Aurora Energy's proposal to customise its prices and quality standards

Draft decision

Date of publication: 12 November 2020

Figure C1 Aurora's recent SAIDI performance against DPP3 standard

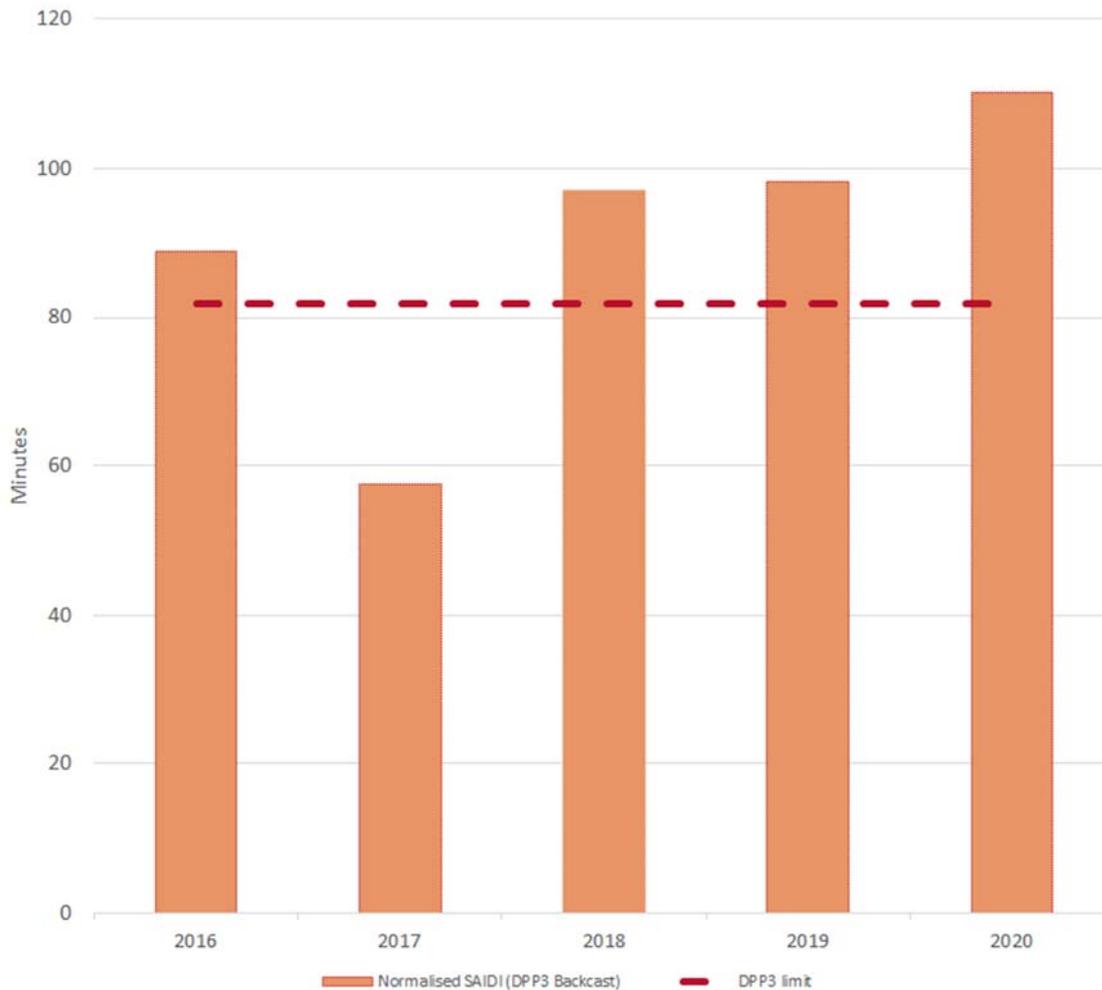
C47 Figure C1 below shows that Aurora would need to achieve a step change improvement in its reliability performance over the next few years to adhere to the DPP3 standard. We do not think this is a reasonable expectation over the CPP period.

Figure C2 Aurora's proposed unplanned SAIDI targets and limits

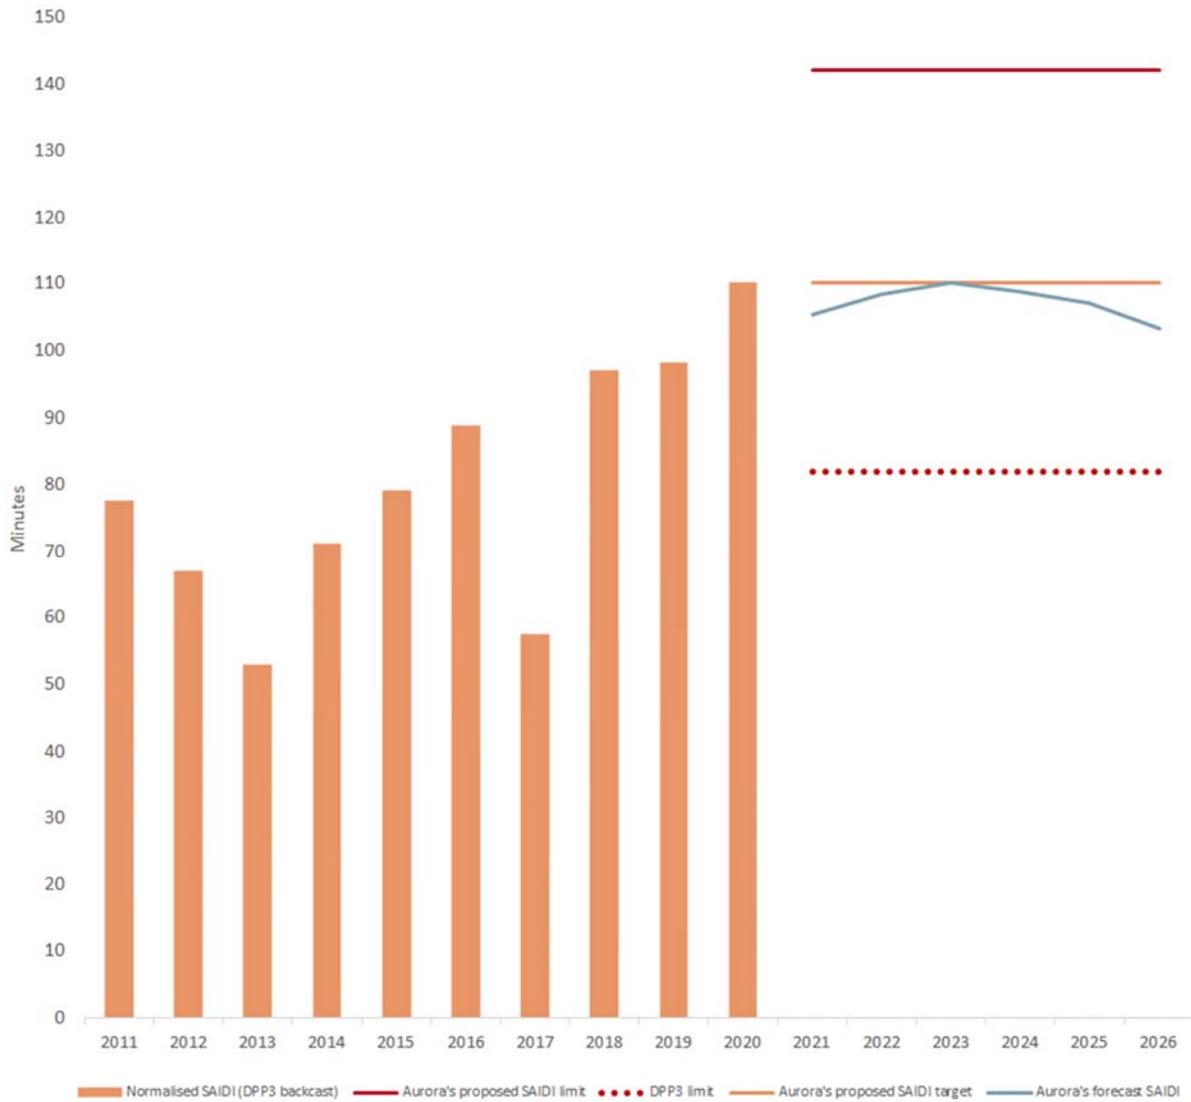
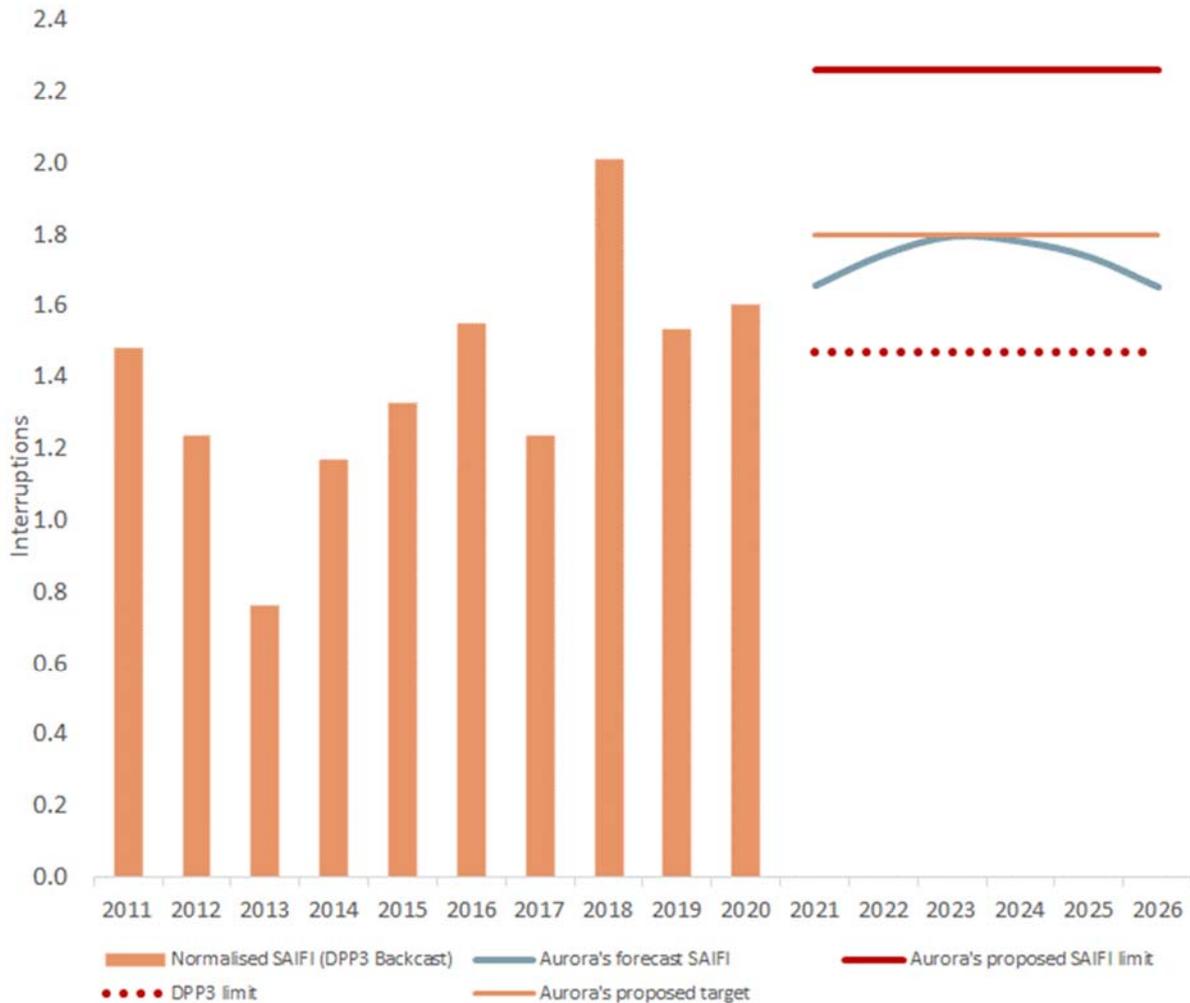
C49 Figure C2 and Figure C3 show that Aurora's proposed unplanned SAIDI and SAIFI targets and limits are worse than its normalised historical experience, reflecting an expectation of more frequent and longer outages.

C51 Aurora's CPP proposal did not apply the DPP3 normalisation approach consistently. In our view, it presented a less meaningful comparison, which suggested its reliability deterioration was less than the 19% SAIDI and 10% SAIFI deterioration included in Figure C2 and Figure C3.²¹⁴ This is because in its CPP submission:

C51.2 Aurora did not correctly apply the DPP3 normalisation method to its SAIDI and SAIFI forecasts.²¹⁶ Aurora later corrected for this in an updated forecast it provided for our consideration (shown in Figure C2 and Figure C3). Aurora's updated forecasts include lower unplanned targets and limits than its submitted proposal. These differences are small for SAIDI (about 2%) and more substantial for SAIFI (about 10%).²¹⁷ For simplicity, we refer to Aurora's updated forecasts as its proposal throughout this attachment.

- C58 Compared to Aurora's proposal which heavily relies on its reliability performance over the 2018-2020 period, our draft inclusion of 2017 in the reference period provides a wider range of relatively high, medium, and low outage years to predict Aurora's future performance. This is shown in Figure C2 and Figure C3 above.

Figure C5 Annual SAIFI forecasts - by Aurora and the Verifier

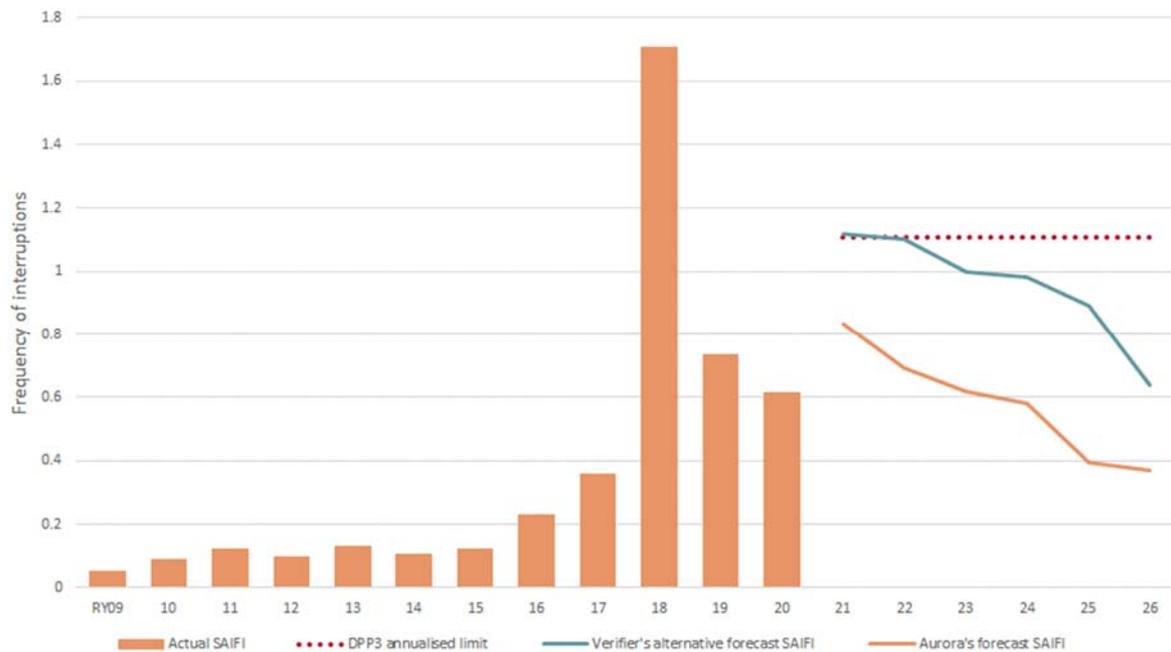
- C86 If the planned outage standard were annualised rather than spanning the entire CPP period, it would be about 1.11 SAIFI interruptions each year. Figure C5 below shows that if Aurora's planned outages followed the Verifier's forecasts, there would be a clear risk that Aurora would need to adjust its timing of network investment works across the CPP period to meet an annualised planned outage standard. This could be inefficient.

C87 We consider that in practice, the annual variation in planned SAIDI and SAIFI may be even greater than forecast for such a large programme of network investment. We note that there was substantial annual variation in planned outages in the five previous years, as shown above in Figure C5. Aurora's significant increase in planned outages since 2018 is when it started addressing its historic underinvestment. Annual planned outage quality standards could inadvertently constrain Aurora's implementation of the CPP's network investment.

Figure D1 Capex proposal and draft decision allowance compared with DPP allowance estimates and historical expenditure

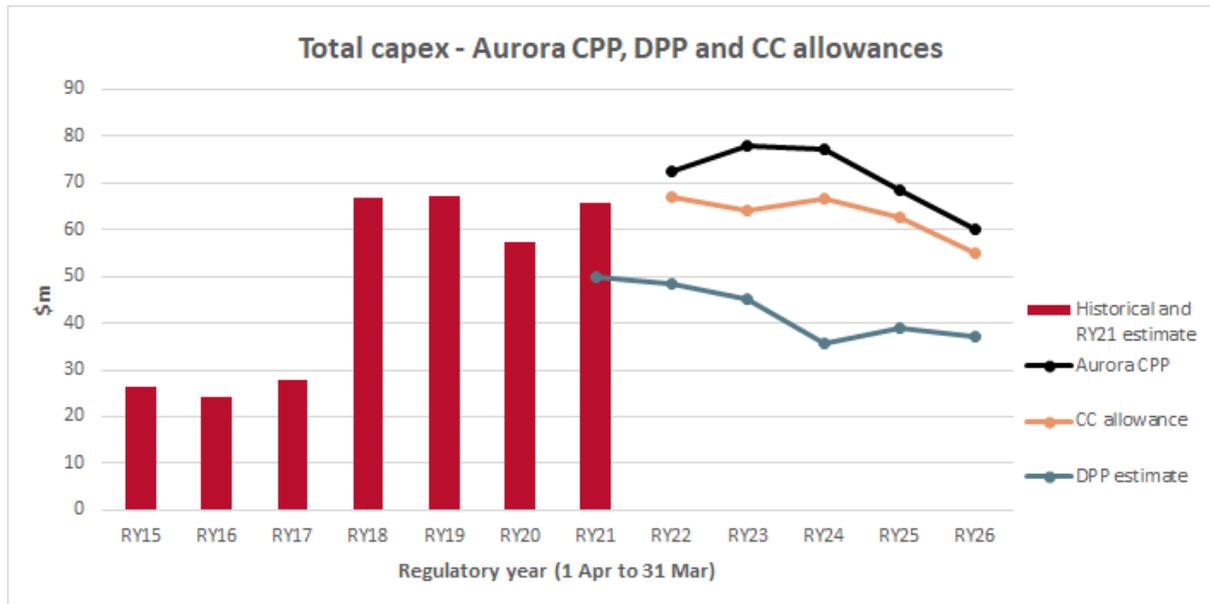
D4 Our draft decision is that Aurora be allowed \$315.5 million of its proposed \$356.3 million in capex over the five-year CPP period, which is a reduction of \$40.9million on what it proposed (see Figure D1).
